UNITED STATES
DEPARTMENT OF THE INTERIOR
BUREAU OF LAND MANAGEMENTOCD Artesia
RECEIVED
JUL 01 2013FORM APPROVED
OMB NO. 1004-0135
Expires: July 31, 2010**SUNDRY NOTICES AND REPORTS ON WELLS**
Do not use this form for proposals to drill or to re-enter an abandoned well. Use form 3160-3 (APD) for such proposals.

☒ Oil Well ☐ Gas Well ☐ Other8. Well Name and No.
GOVERNMENT D 15

CHESAPEAKE RESPECTFULLY SUBMITS THE FINAL PROCEDURE TO PLUG AND ABANDON THE FOLLOWING:

Current Wellbore Schematic

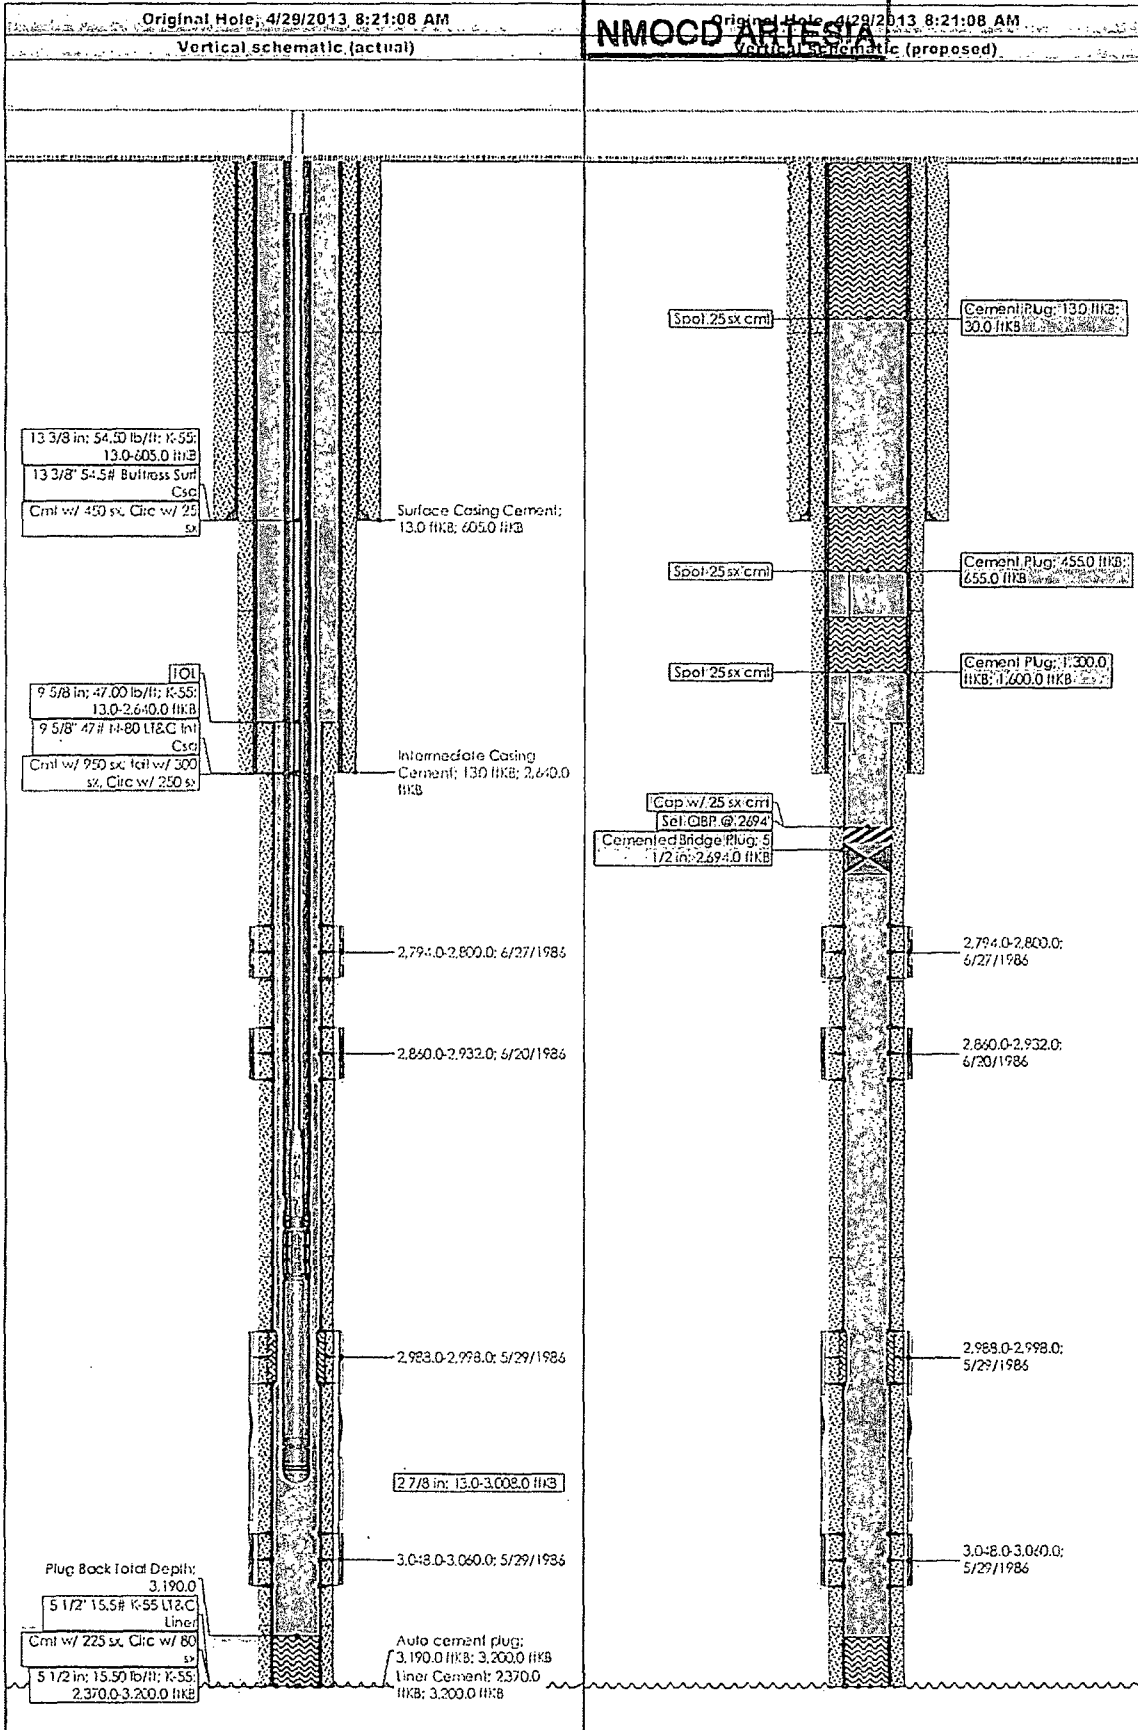
6. Puh. To ~~4699?~~ spot 25 sx. Cmt. WOC & Tag.

8. Puh. To ~~30?~~ spot 25 sx. Cmt. WOC & Tag.

spot adequate to bring cnt to
1248' 2320' WOC Tag
60'-Surf

60-Surf

FORMATIONS:
 1148 (Capitan)
 1248 woc Tan, Capitan 1198
 2320 woc Tan, Del. 2792
 2062370 Cherry Cyn 2970

Covers
 95/8" shoe
 & Liner Top.
 & T/Del.
